## **EISENHOWER MEMORIAL**

**NATIONAL CAPITAL PLANNING COMMISSION**

SUPPLEMENTAL SUBMISSION FOR PRELIMINARY DESIGN REVIEW

SUBMISSION DATE: AUGUST 29, 2014

## EXECUTIVE SUMMARY OF DESIGN REVISIONS

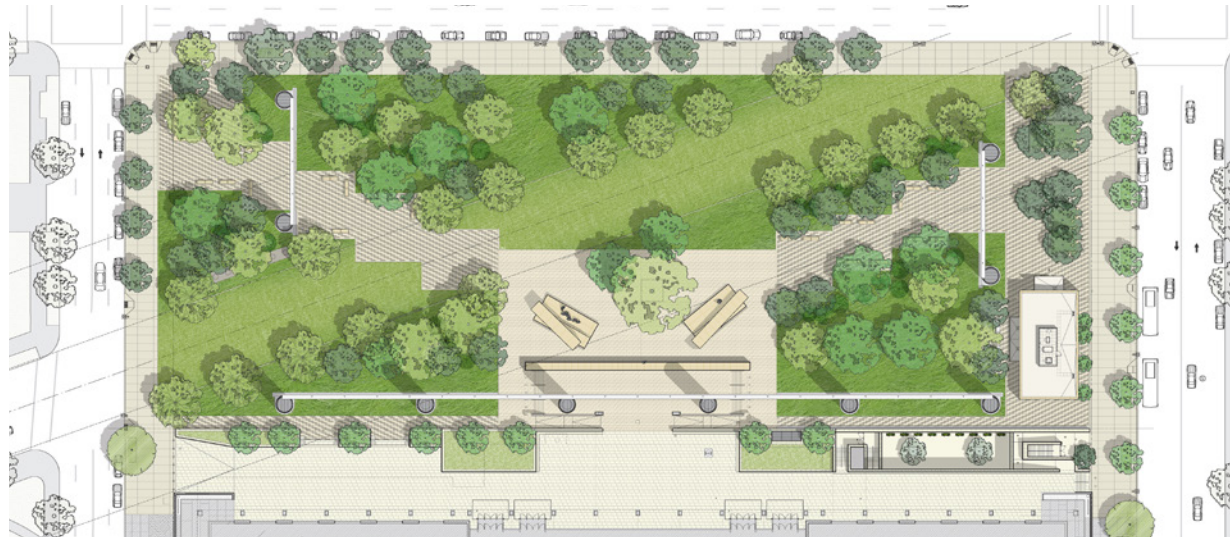
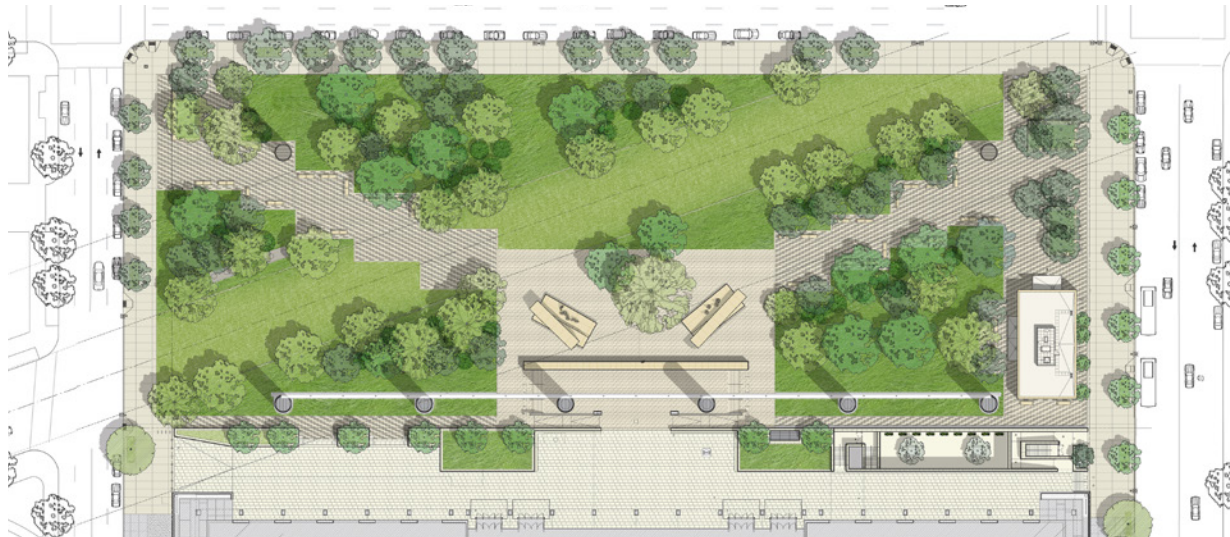
The Memorial design was reviewed by the NCPC Commission in April 2014 for preliminary review. The Commission found the design inconsistent with three of the seven design principles listed below and requested the design be modified to meet the design principles.

*Design Principle 1: Preserve Reciprocal views to and from the U.S. Capitol along Maryland Avenue SW.*

*Design Principle 4: Reflect the L'Enfant Plan principles by shaping the Memorial site as a separate and distinct public space that complements the Department of Education Headquarters and other surrounding buildings.*

*Design Principle 6: Respect the building lines of the surrounding rights of way and the alignment of trees along Maryland Avenue.*

The Memorial design has evolved in response to the April 2014 NCPC Commission Action. The design changes specifically address the three design principles the Commission found inconsistent with the previous submitted design.

**Design Principle 1: Preserve reciprocal views to and from the U.S. Capitol along Maryland Avenue SW.** The revised design has widened the view corridor from 95' to 135'. This design creates a more proportionally *horizontal* framed view of the U.S. Capitol.

**Design Principle 4: Reflect the L'Enfant Plan principles by shaping the Memorial site as a separate and distinct public space that complements the Department of Education Headquarters and other surrounding buildings.** The design revisions eliminate the East and West tapestries allowing the influence of the adjacent buildings to define and unify the site.

**Design Principle 6: Respect the building lines of the surrounding rights of way and the alignment of trees along Maryland Avenue.** The proposed northern singular columns are set back more than 47' from the Independence Avenue Right of Way and are fully located within the planes of the adjacent building facades.

AERIAL VIEW - The design revisions eliminate the East and West tapestries, allowing the influence of the adjacent buildings to help define and unify the site.

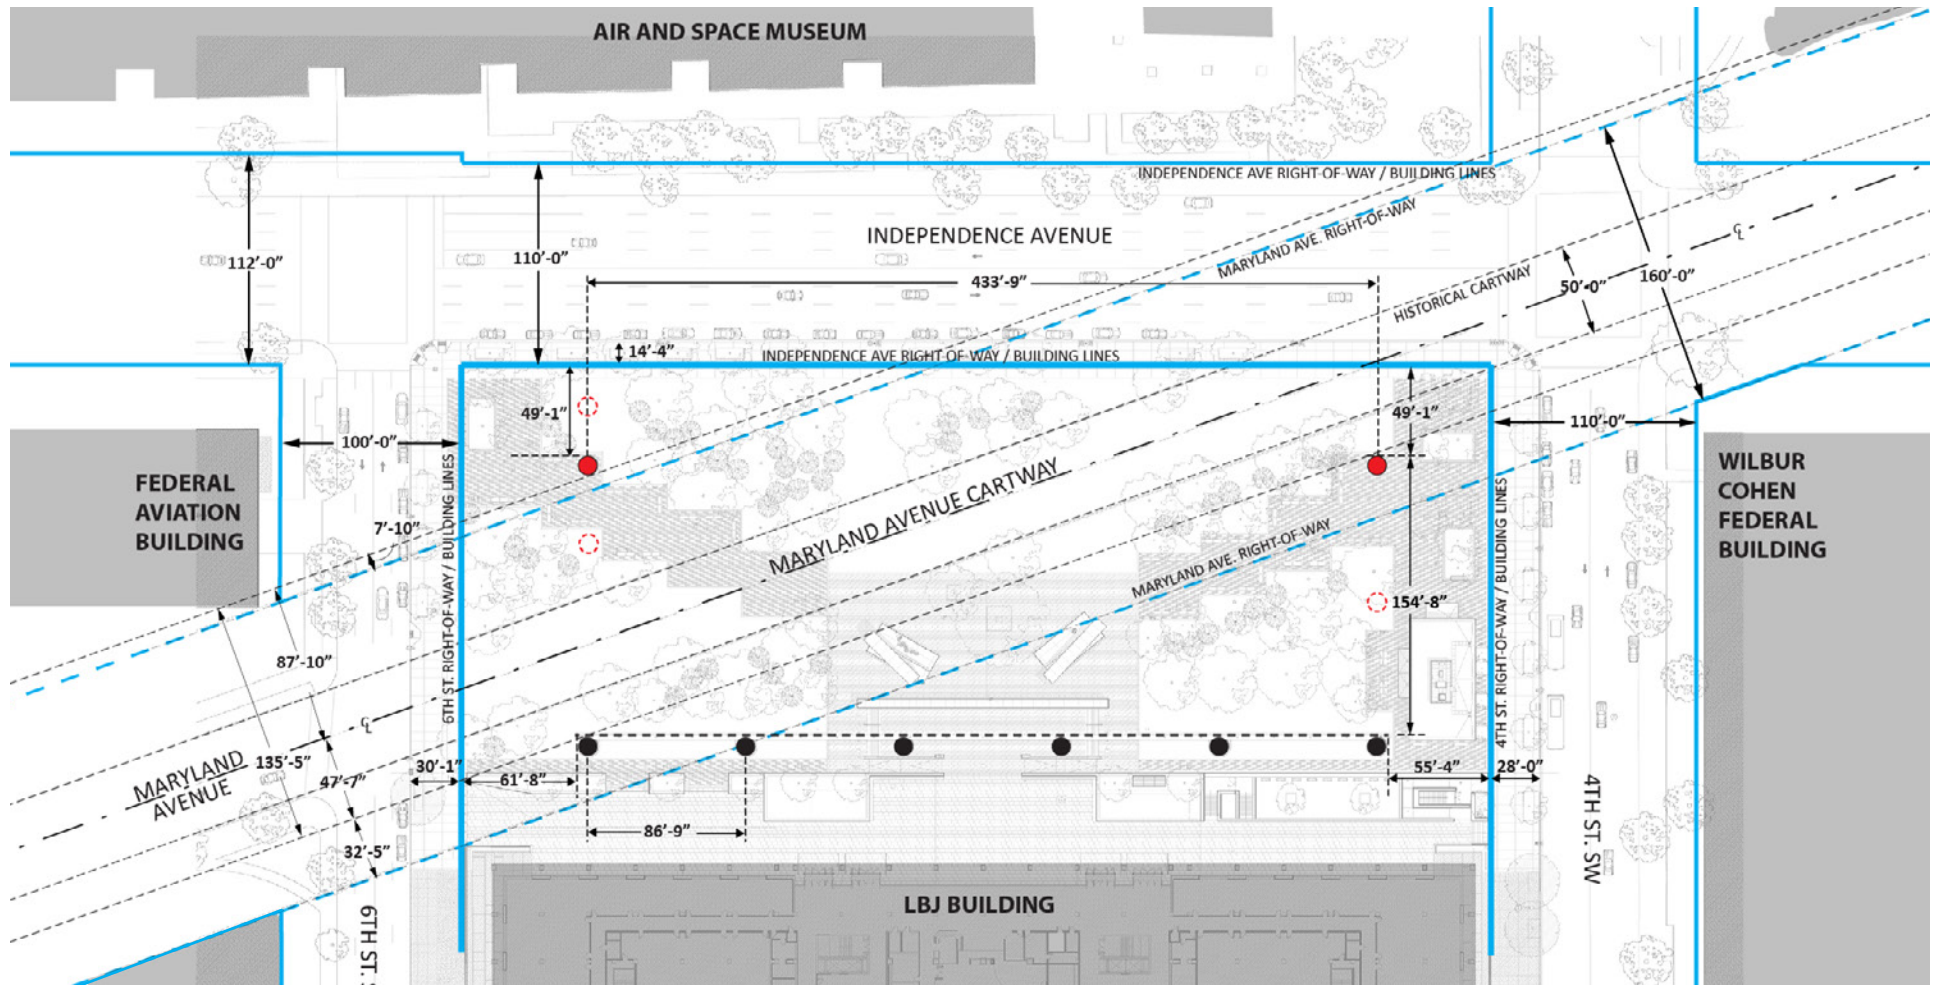
**NCPC ON DESIGN PRINCIPLE 1:** “The scale and configuration of the columns and tapestries within the 160-foot right-of-way continue to obscure the view towards the U.S. Capitol. While the tapestries clearly fall within the category of artwork, their scale and configuration, which narrows the viewshed from 160’ to 95’ with columns that are 78’ high and 10’ in diameter results in a substantial diminution of what is intended to be one of the L’Enfant Plan’s most symbolic and monumental views.

**NCPC ON DESIGN PRINCIPLE 4:** “The placement of the east and west tapestries also takes away from the success of the urban park as a unifying element within the precinct. Rather, the spatial relationship is established more between the adjacent buildings and the tapestries as opposed to the Memorial core and the surrounding park.” *Executive Director’s Recommendation, Page 35*

**NCPC ON DESIGN PRINCIPLE 6:** “Regarding Independence Avenue, while the changes to the tapestry configuration address comments from the concept stage, the current design has created a new issue that causes inconsistency with this principle. Specifically, the realignment of the smaller tapestries has resulted in the column at the northwest corner extending beyond the building line established by the adjacent buildings to the east and west (Wilbur Cohen Building and Wilbur Wright Building) creating a visual intrusion into the existing view along Independence Avenue.” *Executive Director’s Recommendation, Page 36.*

**DESIGN RESPONSE TO NCPC DESIGN PRINCIPLE 1:** The design revisions widen the Maryland Avenue viewshed from 95' to 135' wide creating a proportionally horizontal framed view towards the Capitol building.

**DESIGN RESPONSE TO NCPC DESIGN PRINCIPLE 4:** The design revisions eliminate the East and West tapestries, allowing the influence of the adjacent buildings to define and unify the site.

**DESIGN RESPONSE TO NCPC DESIGN PRINCIPLE 6:** The northern singular columns are set back more than 47' from the Independence Avenue right-of-way and are located fully within the planes of the adjacent building facades.

- The design revisions eliminate the East and West tapestries, allowing the influence of the adjacent buildings to define and unify the site.
- The northern singular columns are located fully within the planes of the adjacent building facades.
- The design revisions widen the Maryland Avenue viewshed from 95' to 135' wide creating a proportionally *horizontal* framed view towards the Capitol building.
- The April 2014 concept included three columns that were within the 160' ROW. The revised plan includes only two columns within the southern edge of 160' ROW.

AERIAL VIEW TOWARDS SOUTHWEST - The northern singular columns are located fully within the planes of the adjacent building facades.

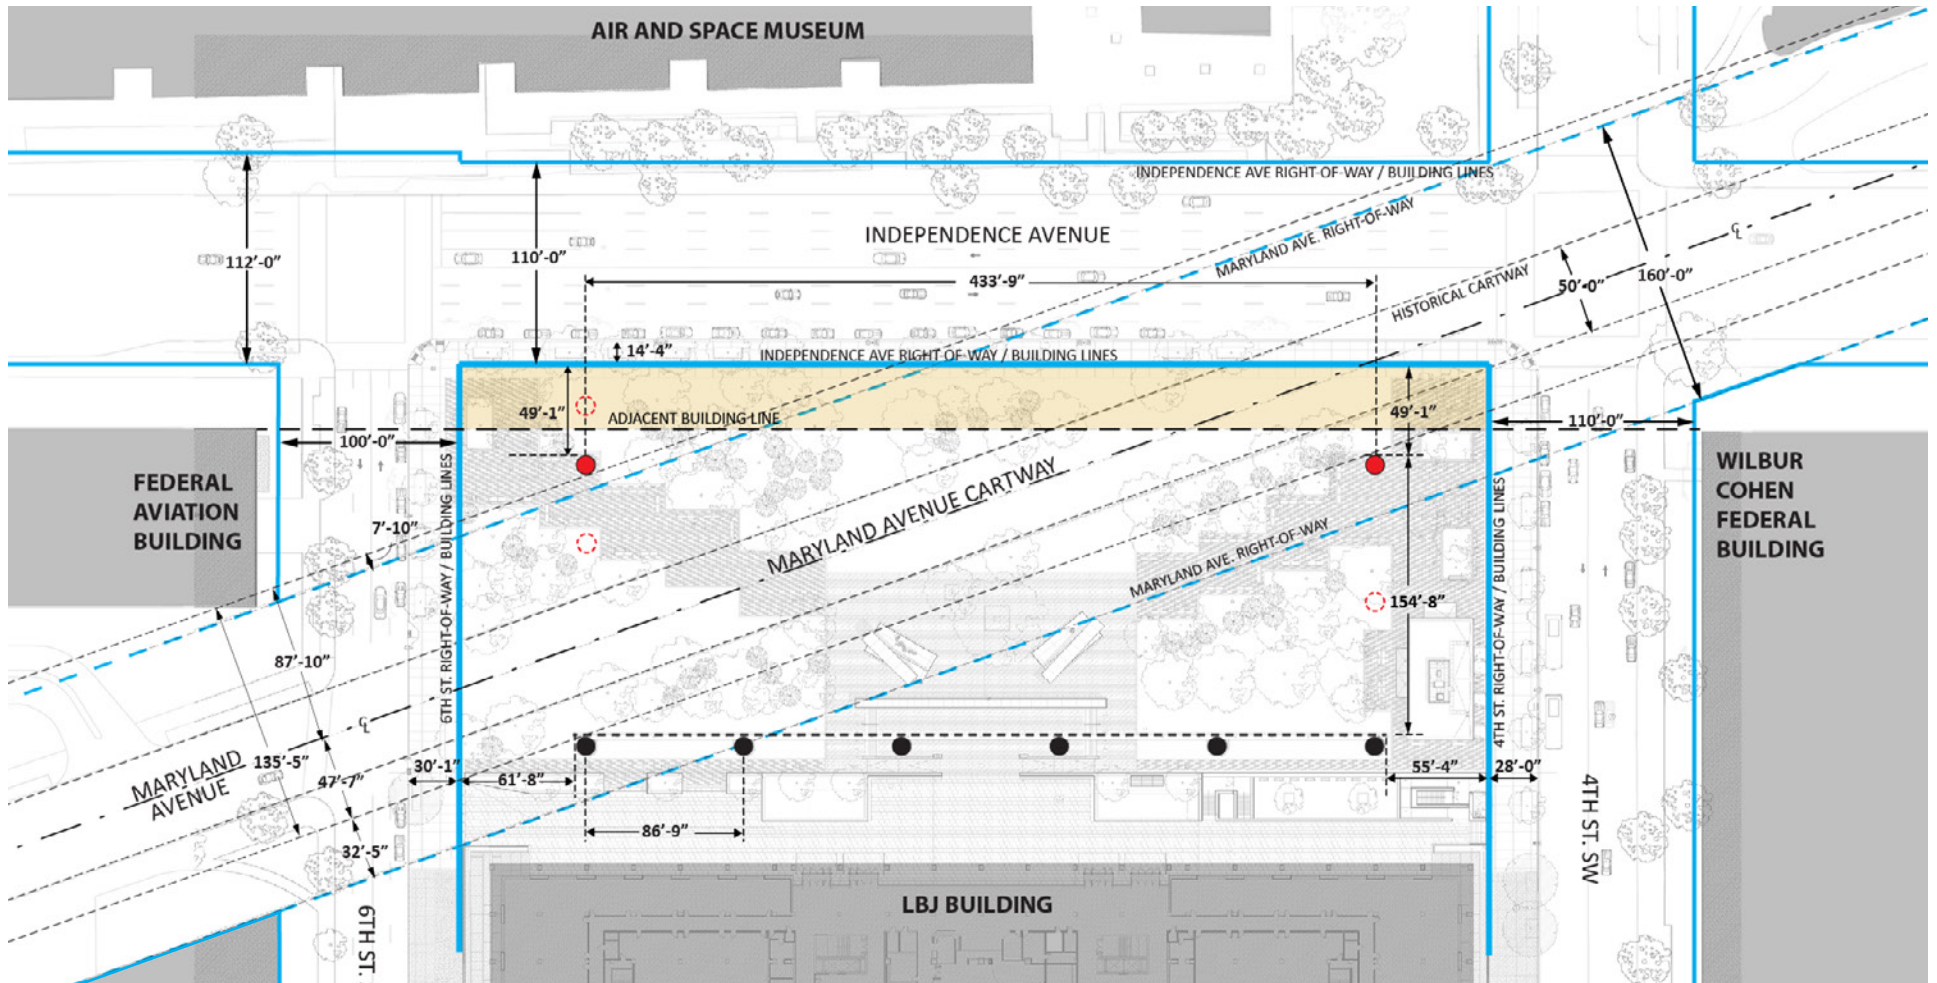
DESIGN PRINCIPLE 4  
REFLECT L'ENFANT PLAN PRINCIPLES BY SHAPING THE MEMORIAL SITE AS A SEPARATE AND DISTINCT PUBLIC SPACE THAT  
COMPLEMENTS THE DEPARTMENT OF EDUCATION HEADQUARTERS AND OTHER SURROUNDING BUILDINGS

DESIGN PRINCIPLE 6  
RESPECT THE BUILDING LINES OF THE SURROUNDING RIGHTS-OF-WAY AND THE ALIGNMENT OF TREES ALONG MARYLAND AVENUE

- Design principle #4 is addressed by eliminating the East and West tapestries, allowing the influence of the adjacent buildings to define and unify the site.
- Design principle #6 is addressed by placing the northern singular columns fully within the planes of the adjacent building facades.

VIEW ALONG MARYLAND AVENUE TOWARDS CAPITOL - The design revisions widen the Maryland Avenue viewshed from 95' to 135' wide, creating a proportionally *horizontal* framed view to the Capitol building.

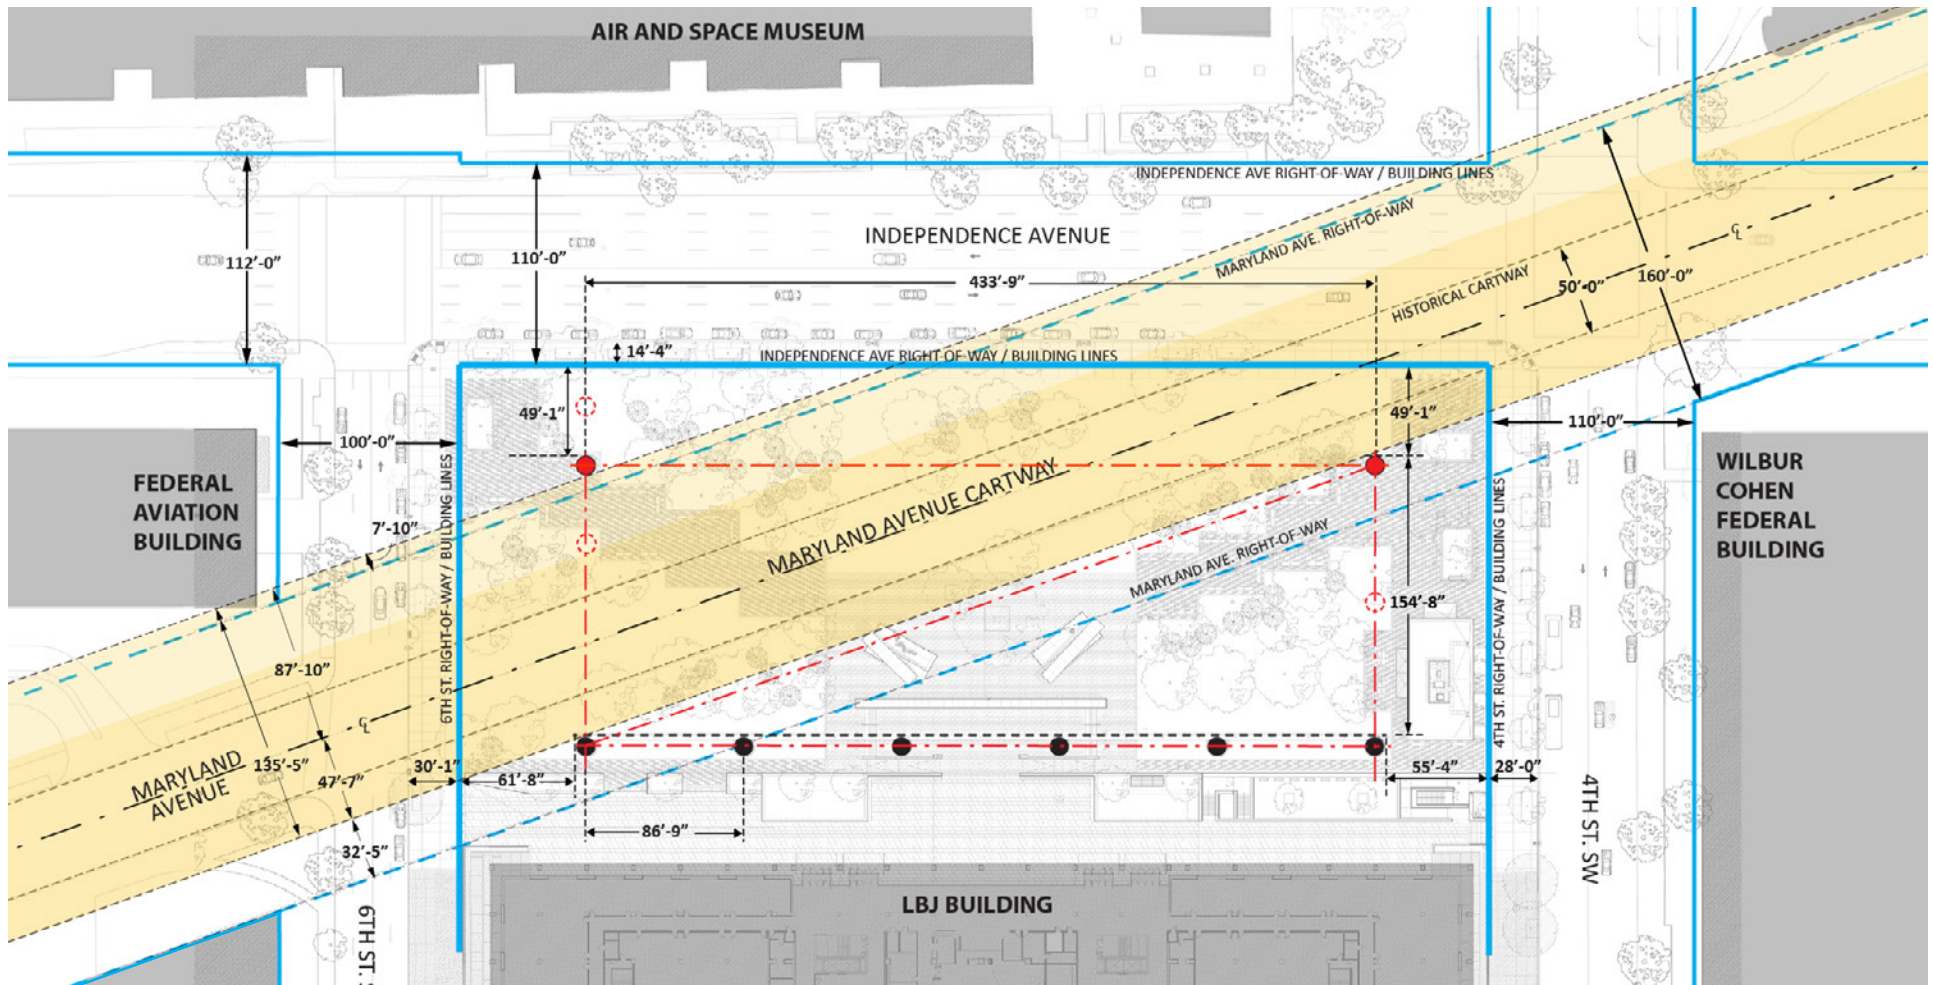
DESIGN PRINCIPLE 1  
PRESERVE RECIPROCAL VIEWS TO AND FROM THE U.S. CAPITOL ALONG MARYLAND AVENUE, SOUTHWEST

- The design revisions widen the Maryland Avenue viewshed from 95' to 135' wide creating a proportionally *horizontal* framed view towards the Capitol building.
- April 2014 concept included three columns that were within the 160' ROW. The revised plan includes only two columns within the southern edge of the ROW.
- The southwest column and northeast column align parallel to the center line of Maryland Avenue.
